**Planning & Development Division**  
*Planning & Economic Development Department*

<b>File Number</b>	PL 22-146	<b>Contact</b>	Chris Lee, clee@duluthmn.gov	
<b>Type</b>	Variance – required driveway locations	<b>Planning Commission Date</b>	September 13, 2022	
<b>Deadline for Action</b>	<b>Application Date</b>	August 11, 2022	<b>60 Days</b>	October 10, 2022
	<b>Date Extension Letter Mailed</b>	August 19, 2022	<b>120 Days</b>	December 9, 2022
<b>Location of Subject</b>	925 East 4 <sup>th</sup> Street			
<b>Applicant</b>	Lunar Legacy, LLC	<b>Contact</b>	David Nelson	
<b>Agent</b>	Heirloom Property Management	<b>Contact</b>		
<b>Legal Description</b>	PIN: 010-3830-15150, 010-3830-15090, 010-3830-15070, 010-3830-15050,			
<b>Site Visit Date</b>	September 1, 2022	<b>Sign Notice Date</b>	August 30, 2022	
<b>Neighbor Letter Date</b>	August 31, 2022	<b>Number of Letters Sent</b>	73

**Proposal**

PL22-146  
Variance  
925 E 4th St

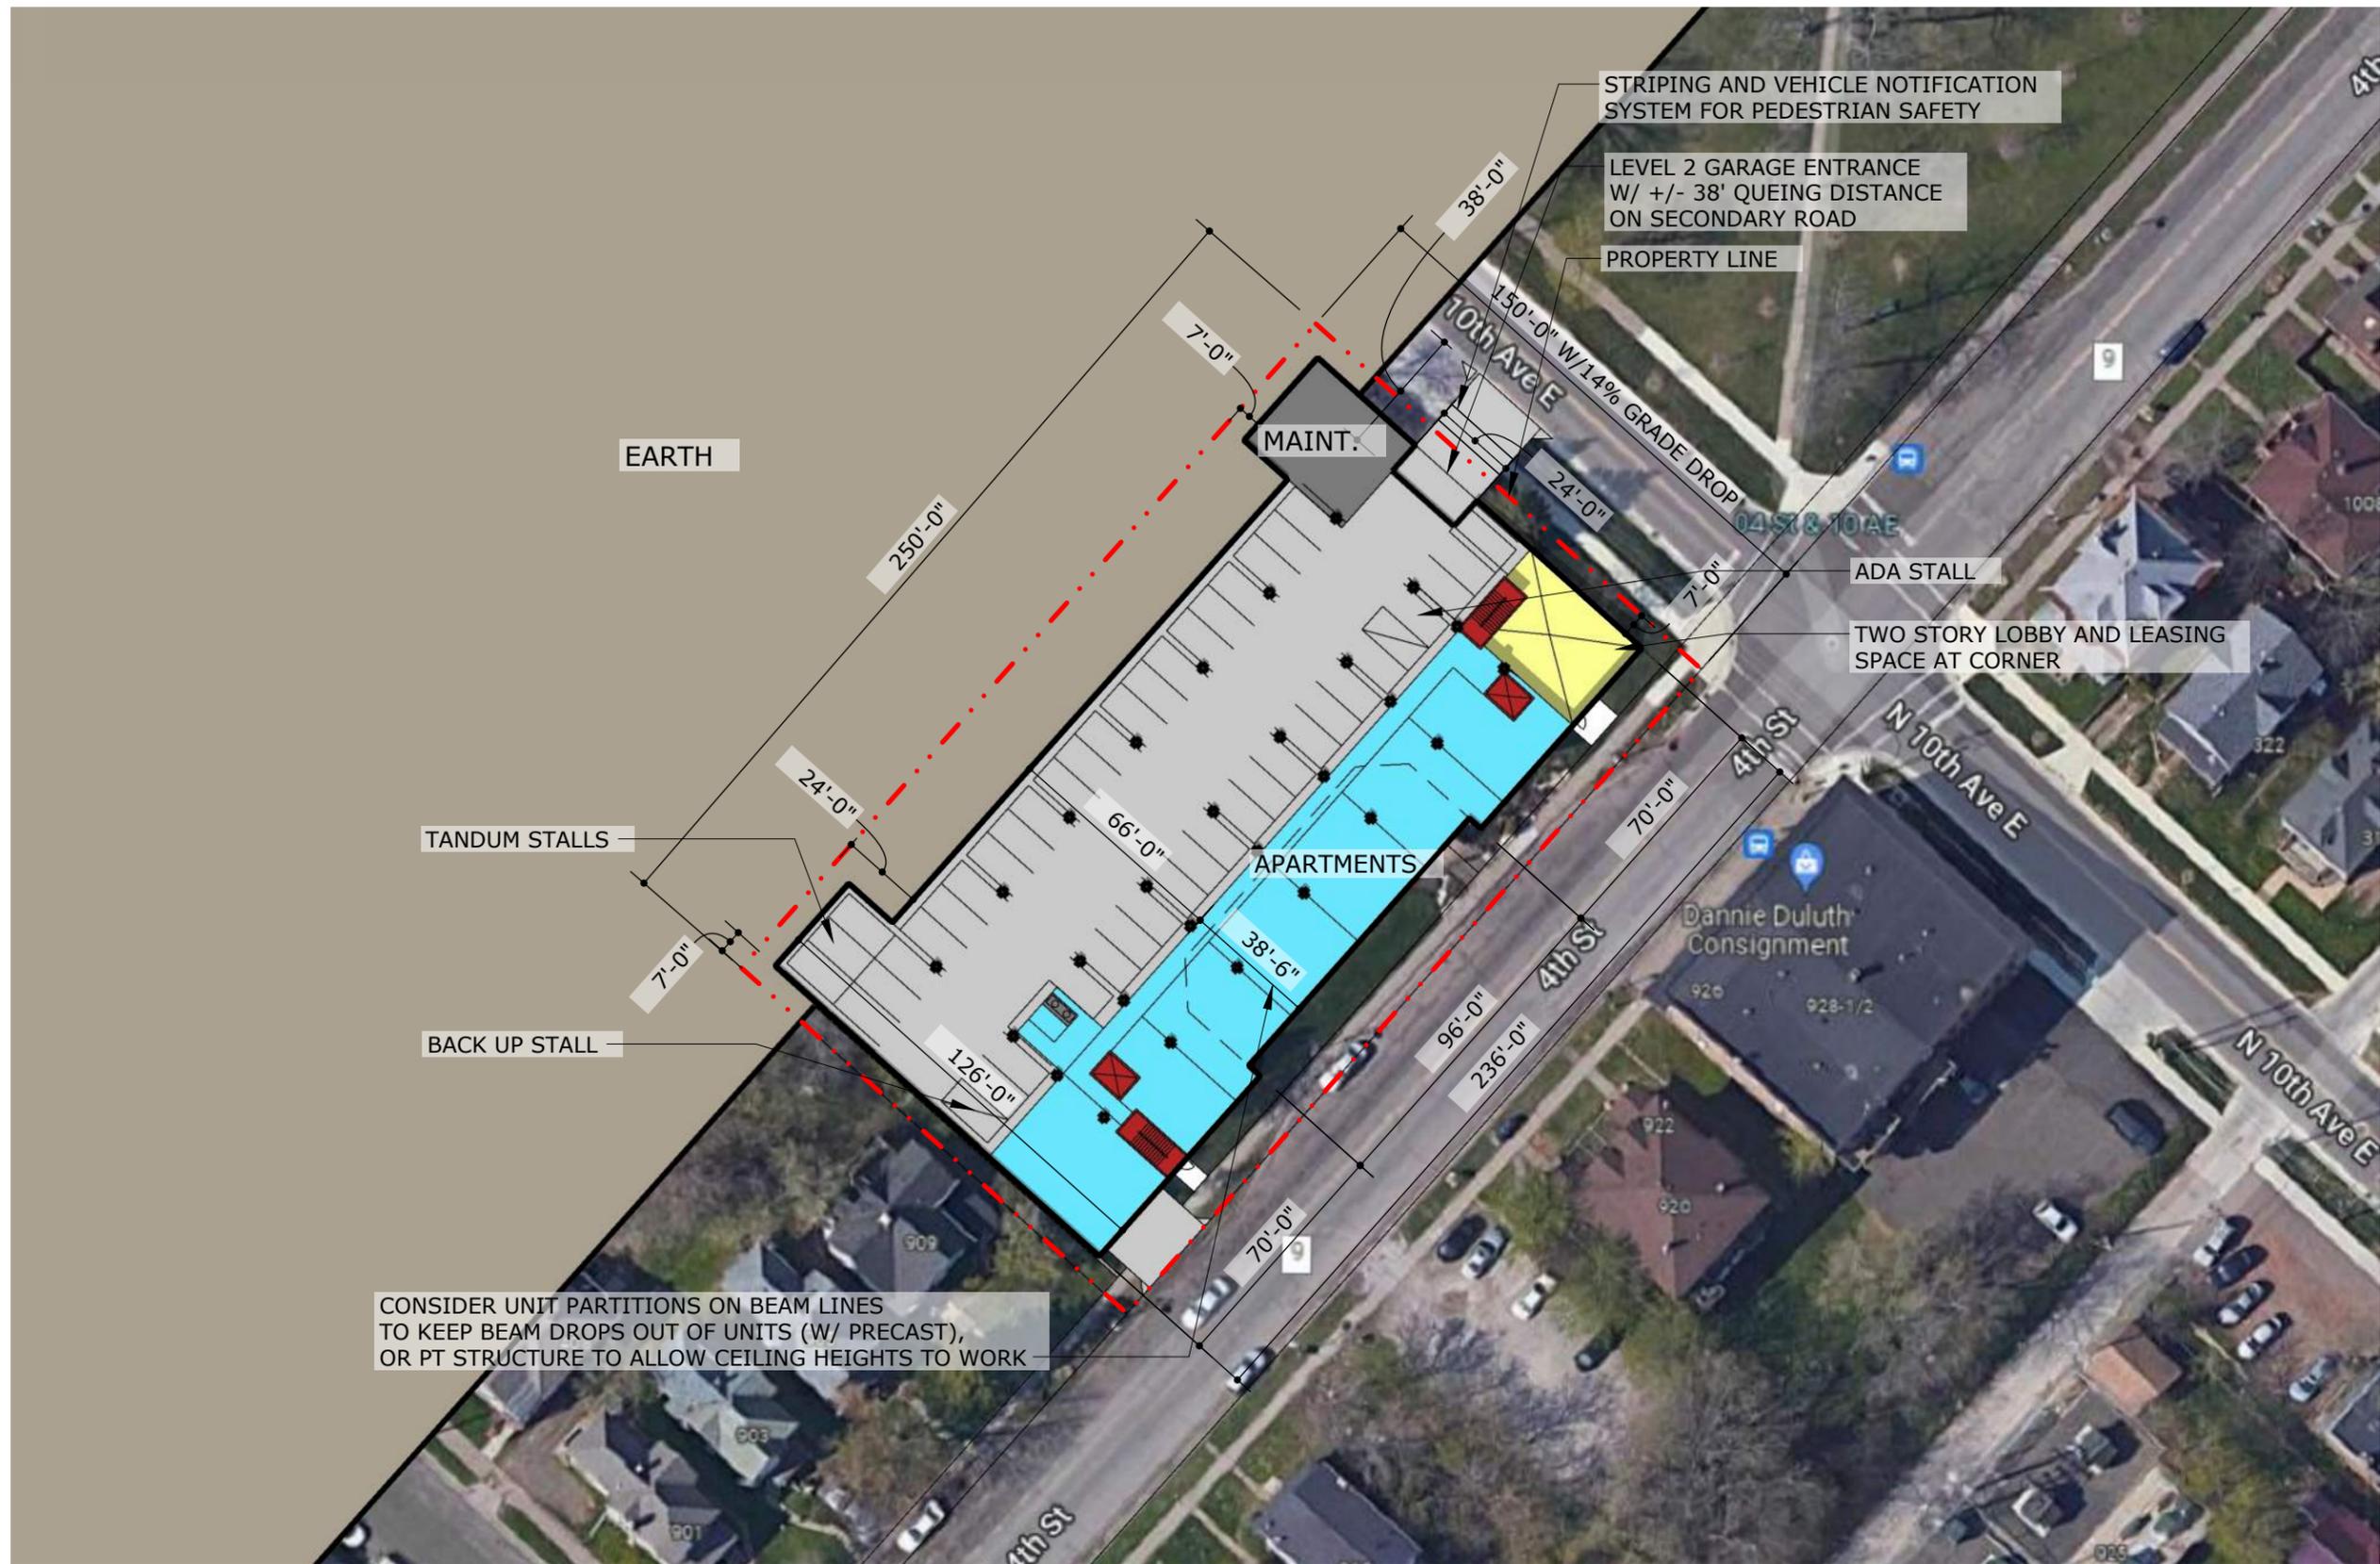
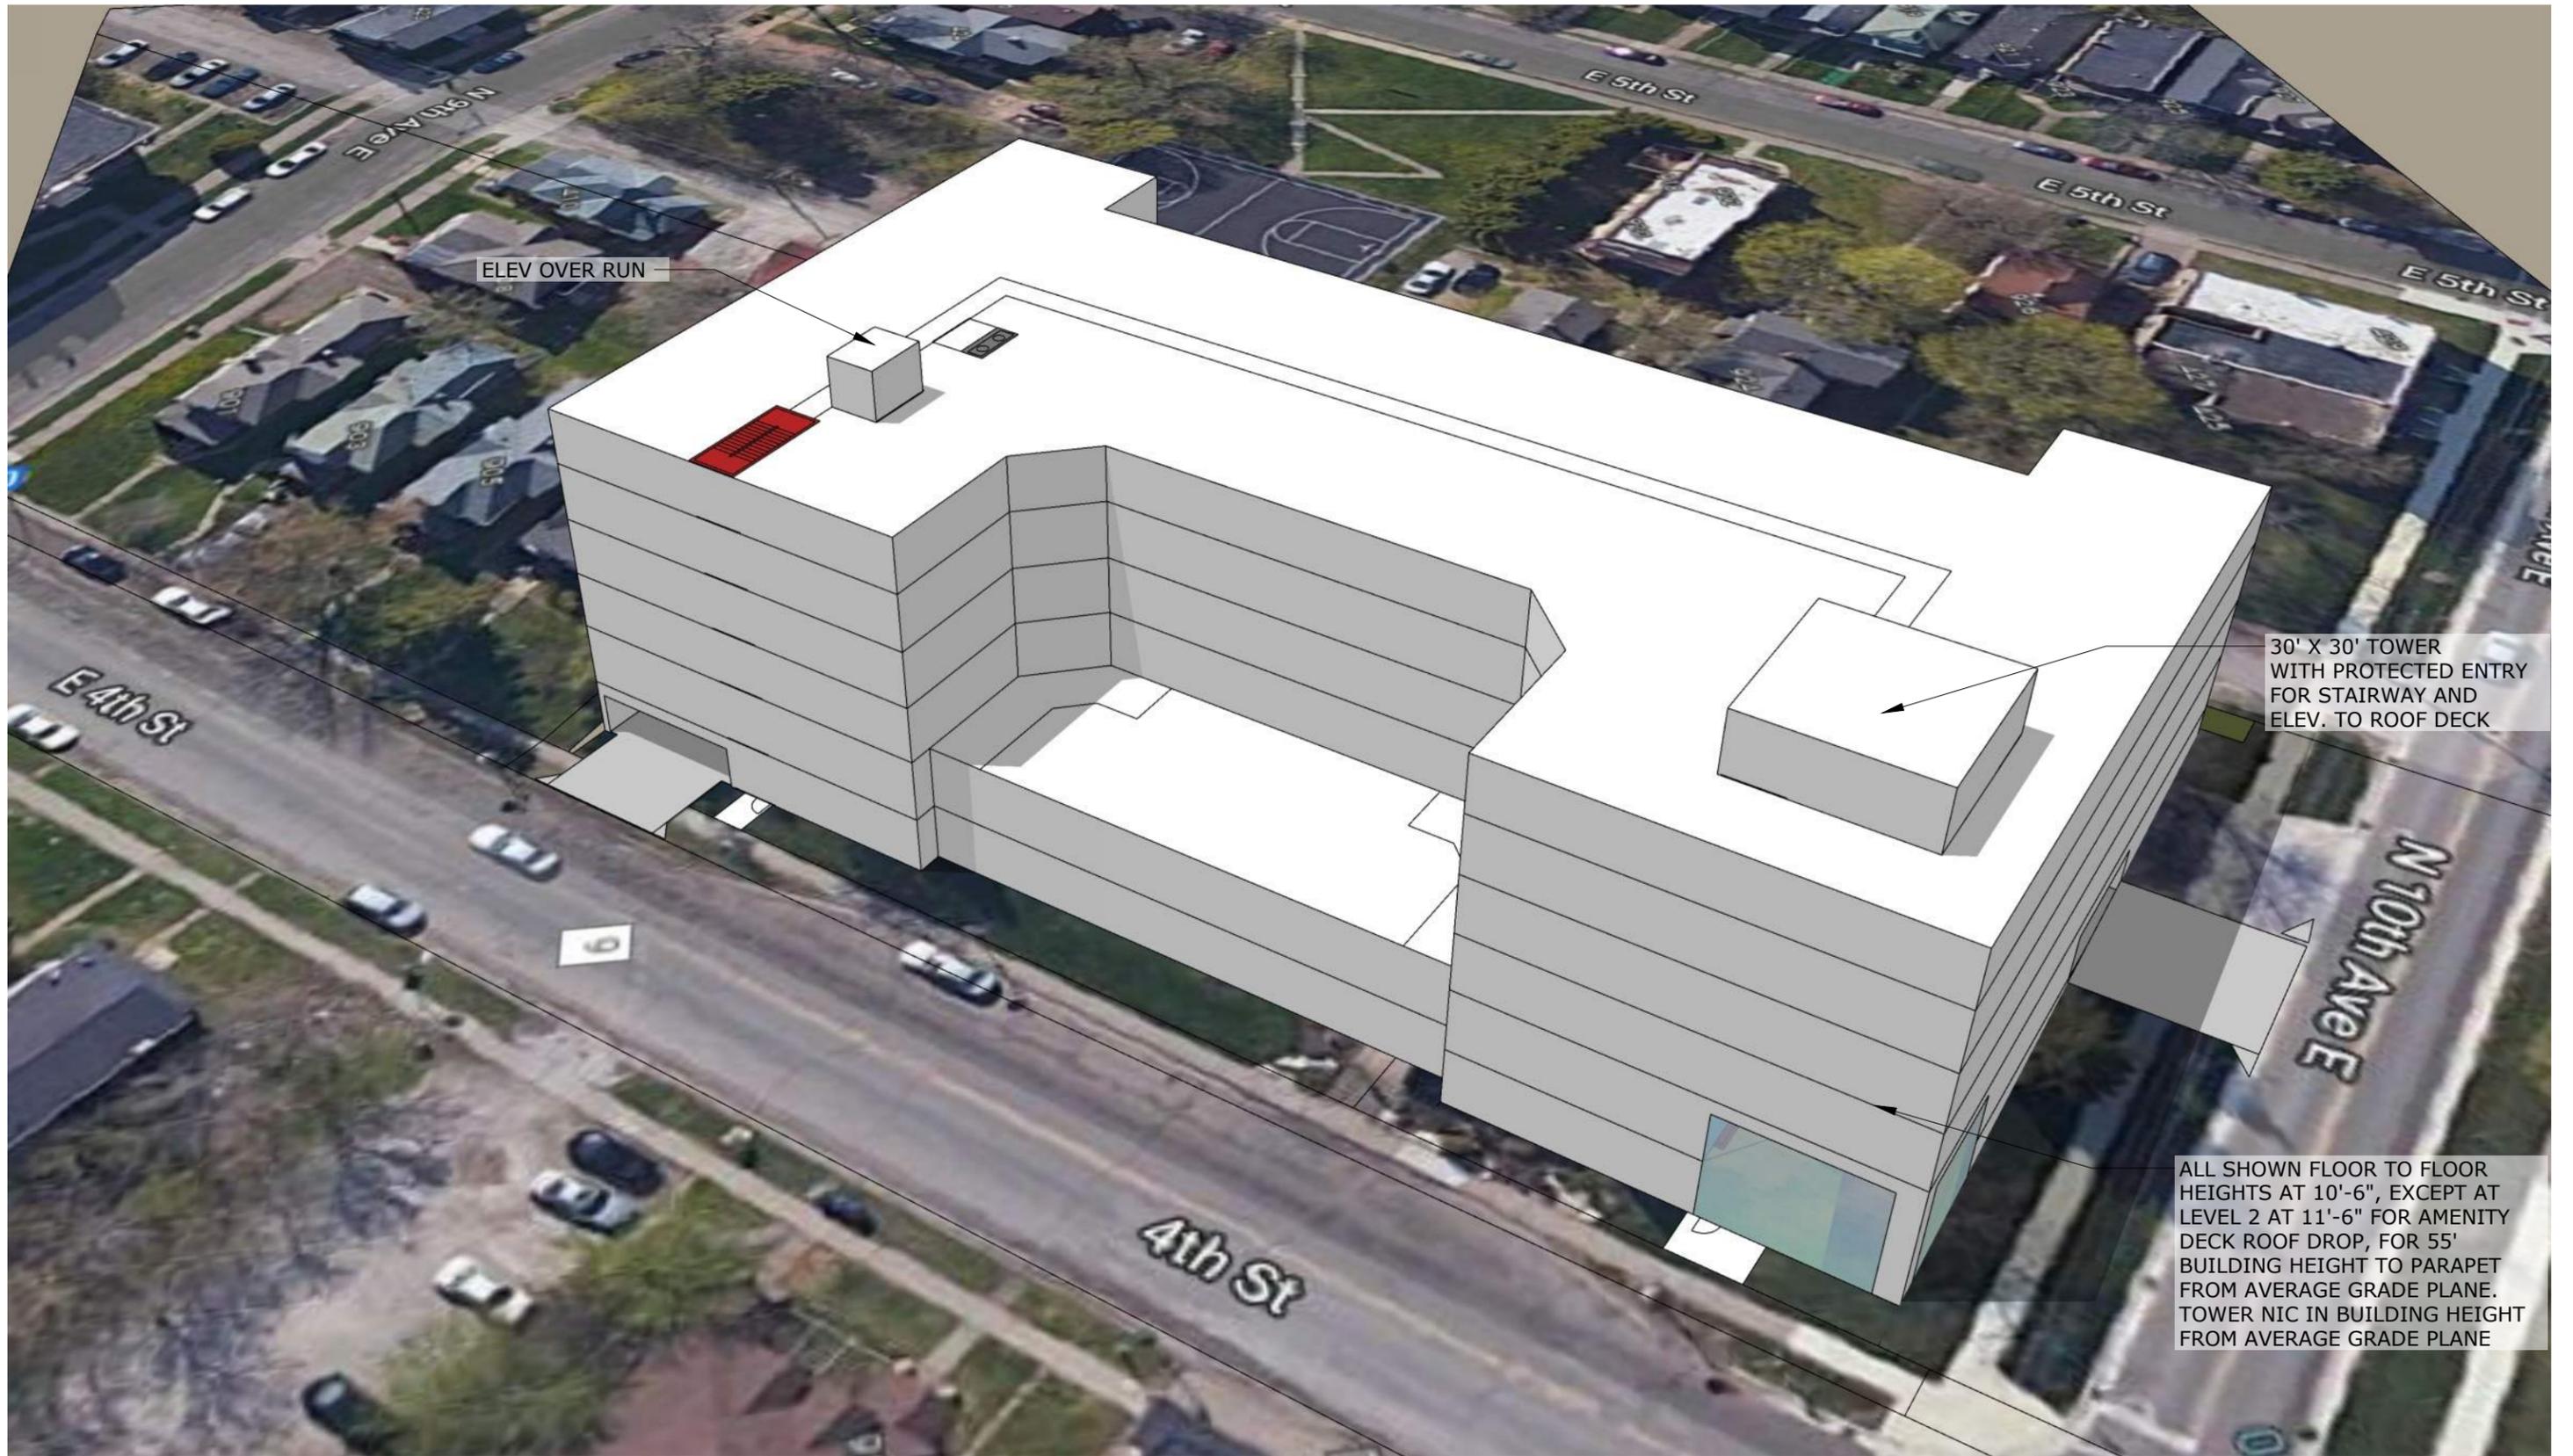
1. Applicant is proposing to construct a 6-story multifamily structure with 121 residential units and 97 covered parking stalls.
2. In F-6, a Corridor II Building is required to have parking access from the alley when the alley is present. The applicant is proposing to have one driveway on East 4<sup>th</sup> St. and one on 10<sup>th</sup> Ave E.

3. The applicant states that the extreme topography makes it difficult to have a single driveway from the alley that can access two floors of parking. The slope on the subject property is 14 degrees from 4<sup>th</sup> St. to alley.

10. St Louis County. Public Works, as the controlling agency of this stretch of 4<sup>th</sup> Street, has approved an additional driveway.
11. The variance, if granted, will not increase fire danger as the Fire Department possesses equipment for fighting fires on structures of this size and larger.

12. Granting the variance is not expected to unreasonably diminish established property values in the area.
13. Granting the variance is not expected to impair the health, safety, or public welfare of inhabitants of the city due to factors identified above. The applicant is proposing a pedestrian warning system on E 4<sup>th</sup> St.

Based on the above findings, Staff recommends that Planning Commission grant the variance to allow a height of up to 40 feet for the properties listed in the legal description above, with the following conditions:

- 1) The project be limited to, constructed, and maintained based on the plans submitted with the application that shows the locations of the driveways.
- 2) A pedestrian warning system is installed to warn sidewalk users a vehicle is approaching.
- 3) Any alterations to the approved plans that do not alter major elements of the plan may be approved by the Land Use Supervisor without further Planning Commission; however, no such administration approval shall constitute a variance from the provisions of Chapter 50.
